Re: Site Plan Control Application
File Number: D07-12-22-0094– 78 Rosemount Avenue

In response to your comments dated August 11th, 2022, I am providing the following information:

78 ROSEMOUNT AVE.

2 ACCESSORY BUILDING FLOOR PLAN

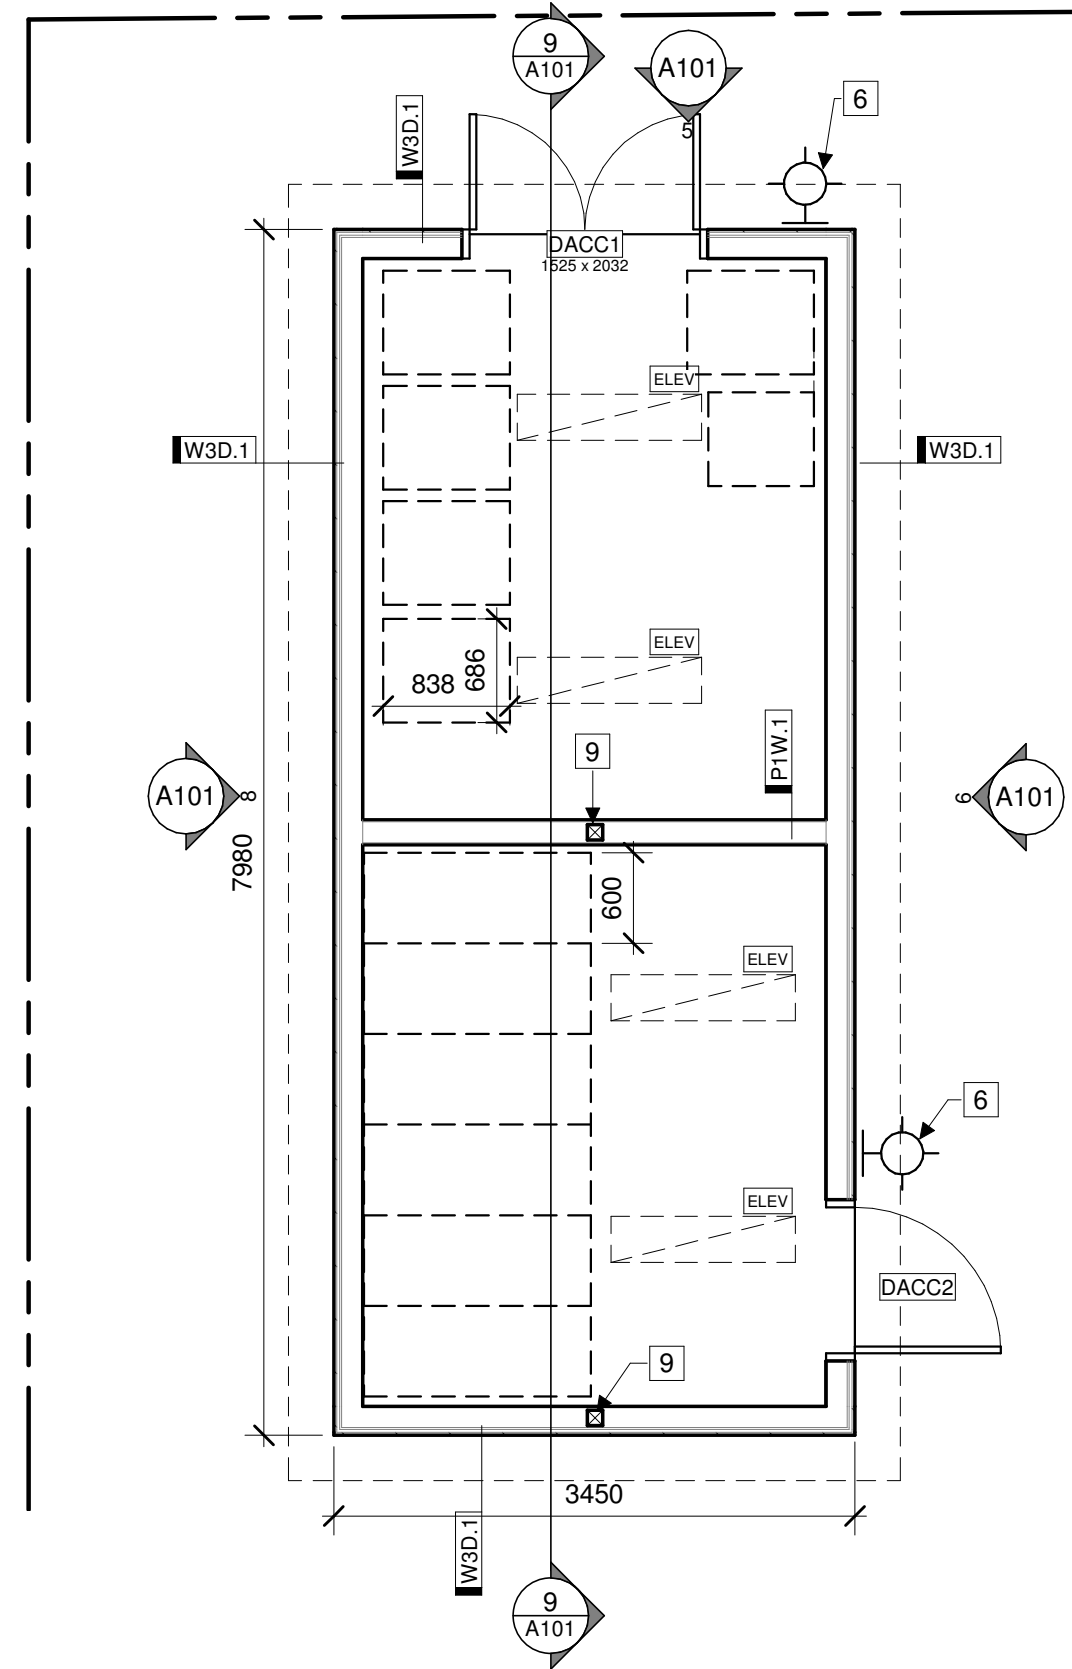
45. Noted, (assuming there was a typo and this is meant to indicate 1 organics bin, rather than 11). The allocated area for these bins is indicated in plan on drawing 2/A101.
